REMARKS

This Amendment is in response to the Office Action dated 01/12/2005. By said Office Action, Claims 1, 2, 4, 9 were rejected and the Specification was objected to under 35 U.S.C. 112, first paragraph, as failing to comply with the enablement requirement. More specifically, the variables A_i , B_i , D_i , E_i and e_i in the claims were indicated as not defined in the claims or the specification. Further in Claim 4, the term "a known power level" was indicated as not defined in the specification. No art was applied to Claims 1, 2, 4 and 9.

AMENDED REPLACEMENT DRAWING SHEET FOR FIG. 8
SN. 10/652,366

FIG. 8

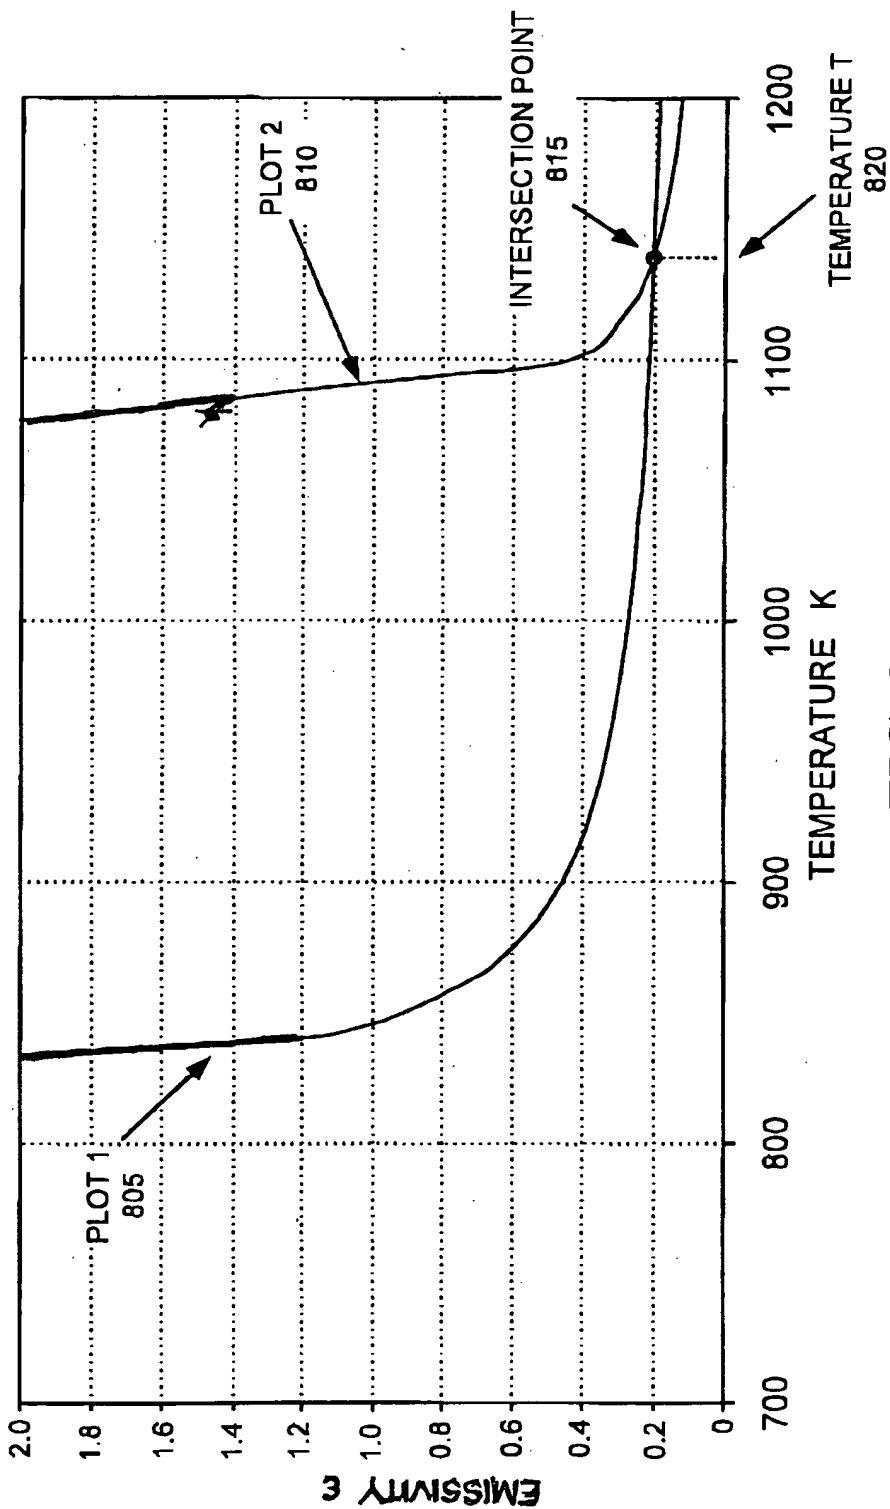
A new Abstract containing between 50 to 150 words was required. The drawings were objected to because Fig. 8 and Fig. 9 do not contain measurement units for the Y-axis.

Marked-Up and Amended replacement FIG. 8 and FIG. 9 are submitted herewith. As noted in paragraph [0013], FIG. 8 is a plot of emissivity versus temperature; and as noted in paragraph [0014], FIG. 9 is a plot of normalized ratios of measured power to calculated emitted power as a function of temperature. The Y-axis of the replacement drawings have been labeled "Emissivity" and "Measured/Calculated Emitted Power ($\frac{A_i}{e_i B_i(T)}$)" (See Eqn. 15 in paragraph [0028]) in FIG. 8 and FIG.9, respectively. Applicant respectfully submits that FIGS. 8 and 9 now comply with the Examiner's requirement.

By this Amendment, a new Abstract of the Disclosure has been submitted having between 50 and 150 words. Replacement amended drawings of Fig. 8 and Fig. 9 having measurement units for the Y-axis have been submitted. Claims 1-7 and 9 have been cancelled. Claims 8 and 10-12 are pending in the case.
